These comments are organized as follows: first, we state language for the two conditions we recommend the Commission include in the new license for Project 2105. Second, we summarize CSPA and AW's June 5, 2020 comments in the Project 2105 docket, in which we laid out the rationale for these two conditions; we have attached our June 5, 2020 comments to the present filing.⁴ Third, we respond to PG&E's October 21, 2020 and December 4, 2020 comments.

I. Specific language for recommended Conditions for inclusion in the Project 2105 license.

**CALIFORNIA SPORTFISHING PROTECTION ALLIANCE AND AMERICAN
WHITEWATER'S COMMENTS AND RESPONSE IN OPPOSITION TO PETITION
FOR WAIVER DETERMINATION
(P-2105-089)
(P-2105-126)**

Figure 1: Historical hydrograph of North Fork Feather River at Canyon Dam site/release from Canyon Dam

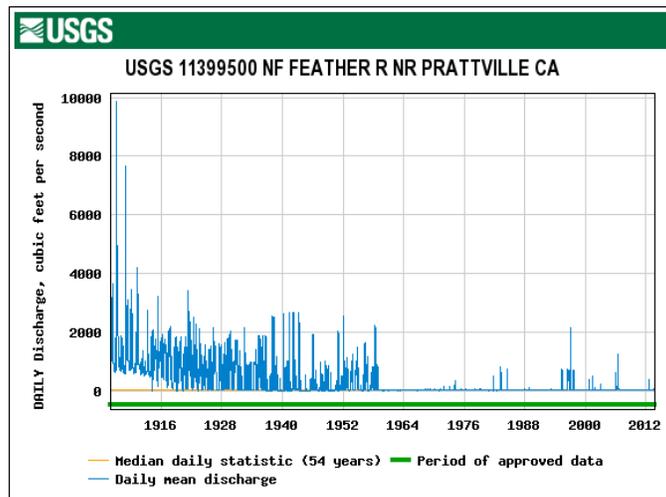
The record for the USGS gauge on the North Fork Feather River near Prattville, located just below Canyon Dam, clearly shows the impact of hydroelectric development on the North Fork Feather River (Figure 1). This record includes the period from 1906 to 1914, before the first incarnation of Canyon Dam was constructed. The record shows that pre-project flows rarely dropped below 800 CFS. After the dam’s construction, flow still remained relatively high until the middle part of the last century. After the final raise of Canyon Dam was completed in 1962,

PG&E was diverting over 95% of the flow from the upper reaches of the North Fork Feather River.

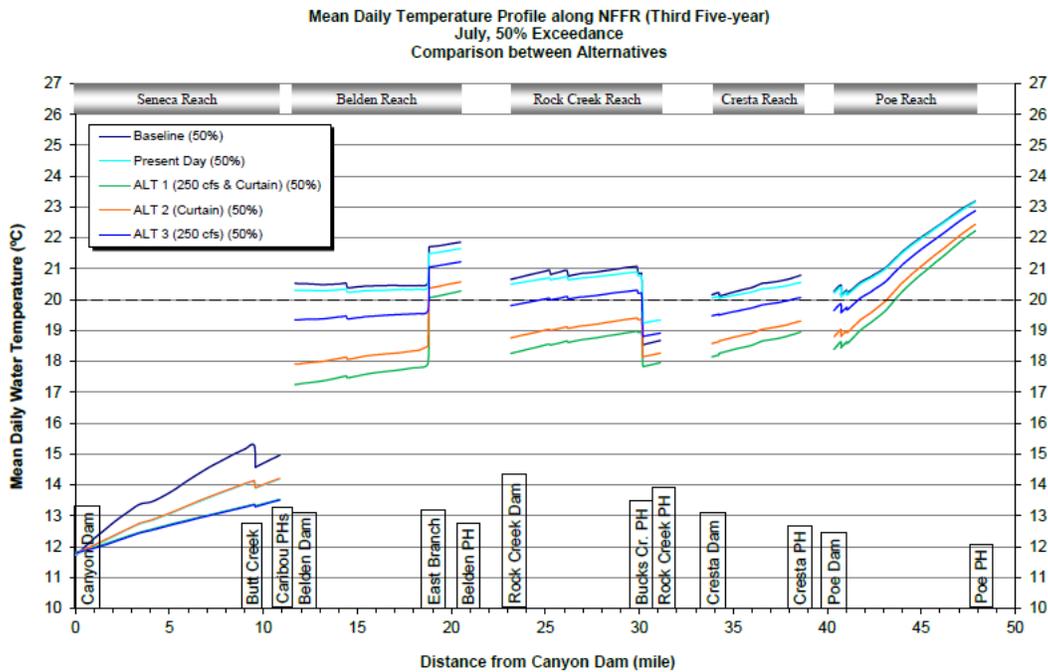
PG&E’s temperature modeling, reported in response to AIR request 13 on August 25, 2003 shows that the discharges from the Caribou powerhouses are on average greater than 5° Celsius warmer than the water in the Seneca reach.⁷⁴ See Figures 4-11 in Attachment 1 to this Response in Opposition. Water discharged from the preferentially-used Caribou 2 powerhouse is warmer than 20°C in July and August two thirds of the time. Appendix E3 of the RDEIR, pp. 9 ff., graphically depicts the huge leap in water temperature between water in the bottom of the Seneca reach and water in Belden Forebay that is discharged from the Caribou powerhouses. Water temperature monitoring performed by PG&E confirms both PG&E and the State Water Board’s modeling. For example, in 2018, mean monthly discharges from Caribou 2 Powerhouse were 17.9°C in June, 20.7°C in July, 20.9°C in August, and 19.3°C in September.⁷⁵

Figure 9 (Normal year), Figure 10 (Dry year) and Figure 11 (Critically Dry year) in Appendix E3 of the RDEIR show that the thermocline in Lake Almanor is consistently higher in elevation under Alternative 3 (250 cfs summer release from Canyon Dam) than under Alternative 2 (thermal curtain alone).⁸⁰ In addition, additional withdrawals from Canyon Dam can be mitigated by oxygenating the water in the vicinity, creating *more* coldwater habitat for fish than exists both under existing conditions and the FERC staff alternative. See discussion of oxygenation facilities, *infra*.

Figure 3: Hypothetical generation hours under Project 2105 Settlement flows (solid line) and with Settlement flows combined with release of 250 cfs from Canyon Dam (dotted line). (Adapted from working model developed in 2020 by PG&E for analysis of flows on the Poe reach)

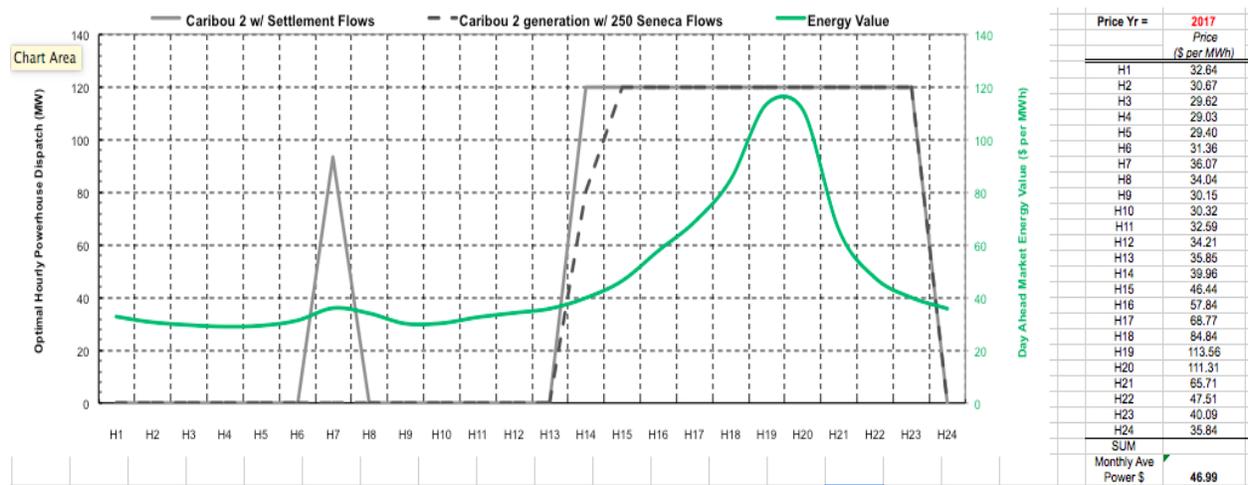
The generation component of Figure 3 provides an example of how releasing supplemental flows in the Seneca reach could impact generation at the Caribou 2 powerhouse. Increasing river flows in the Seneca reach from the required 70 cfs flow in the Settlement to the 250 cfs flow in Condition 6(A) of the Draft Certification would reduce morning generation by about an hour and would also reduce generation by a small amount during the afternoon ramp-up. The August 2017 value of power in those two hours, H7 and H14, was \$36.07/MWh and \$39.96/MWh respectively. This is significantly less than the \$46.99/MWh average power value for the month.
